INDESIT company

LI46

F027245

# Notices

## n1045034: New top condenser.

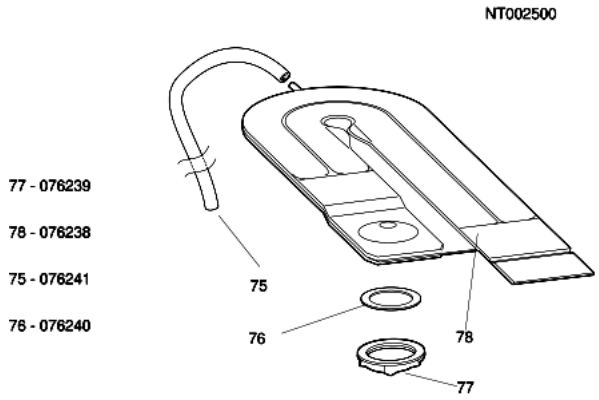
As of the last week in July 2000, the new "Wind drying system" was inserted on some appliances from the new MarckII Range. This new system foresees the elimination of the lateral air-flow body and the insertion of a new system with top condenser.
The spare part numbers eliminated are as follows:

054927(Rohs 144335) - RING NUT FOR AIR-FLOW BODY
054928 - AIR-FLOW BODY
103689 - NOZZLE GASKET
057874 - TOP SOUNDPROOFING LAYER

Whereas the new spare part numbers are:

076238 - WIND DRYNG SYSTEM CONDENSER
076239 - CONDENSER RING NUT
076240 - TOP CONDENSER GASKET
076241 - TOP CONDENSER PIPE

The new part numbers are not interchangeable with the old ones, as they are completely different. See technical drawing attached to notice NT002500.

Photo N1045062FIG1 illustrates the bottom of the dishwasher with EVO structure.

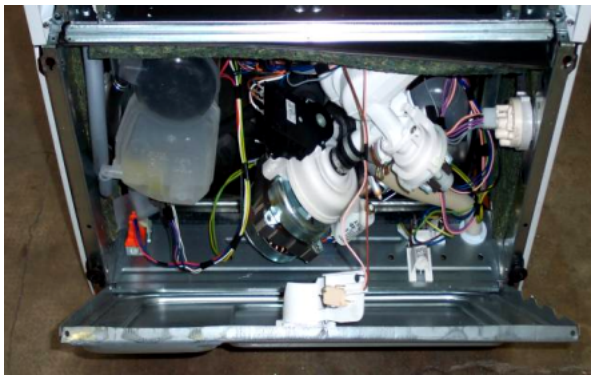
From serial number 30101.0001, all dishwasher models affected by this modification have been produced with EVO structure. These models have been equipped with NEW TRAYS AND NEW FEET (see N1045062TAB1).

EVO STRUCTURE:
Tray: 092558 (for commercial code 28490) 092554 (for commercial code 26043-23520-28088);
Tray rear feet: 092820-092821-092822;
Tray front feet: 092555;
Front feet supports: 065836;
Feet supplied with plinth accessories assembly: 034261.

Regulation assembly DX/SX Sat codes 078397 and 078396 will be managed up to stock end, after that they will be replaced by new Sat codes 092821 and092820. The same is for rear foot Sat code 078385 which will be replaced by Sat code 092822.

N1045063

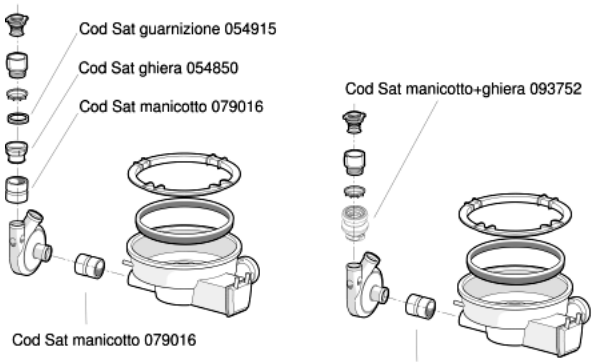
From serial number 30224.0001, all dishwashers affected by this modification have been equipped with the new coupling+ring nut assembly Sat code 093752, in place of coupling Sat code 079016, ring nut Sat code 054850 and gasket Sat code 054915.

Ring nut Sat code 054850 will continue to be available from the spare parts warehouse while stocks last, and coupling Sat code 079016 will continue to be stocked because it is still used for the tank-volute connection.
Picture N1045063 illustrates the premodification structure in FIG1 and the new structure in FIG2.

N1045081FIG1

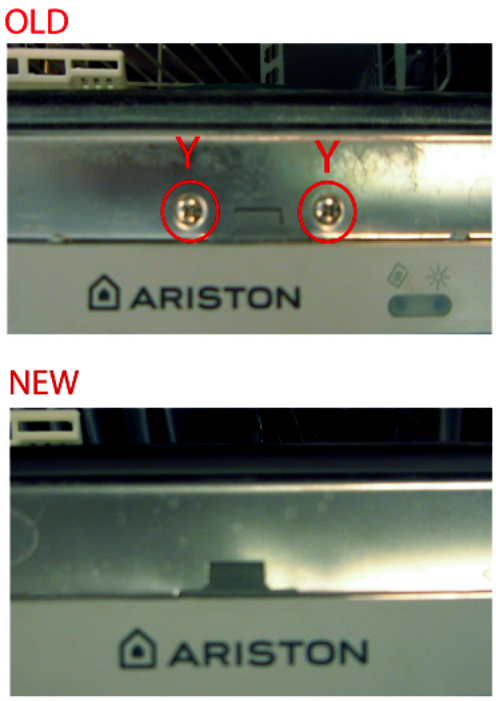
From serial no. 40419.0001, all 45 cm dishwashers affected by this note have been equipped with the locking unit code 094128 in

place of 085357 and 087440.
Following the elimination of the two screws Y (see N1045081FIG1) used to fix the locking unit on the inside door, the locking unit and inside door were also modified, which can be mounted on premodification appliances by replacing the premodification locking unit with the new one.

Codes of modified inside doors:
091542 (EX 088175) PREMODIFICATION - 110184 NEW
091540 (EX 087151) PREMODIFICATION - 110185 NEW
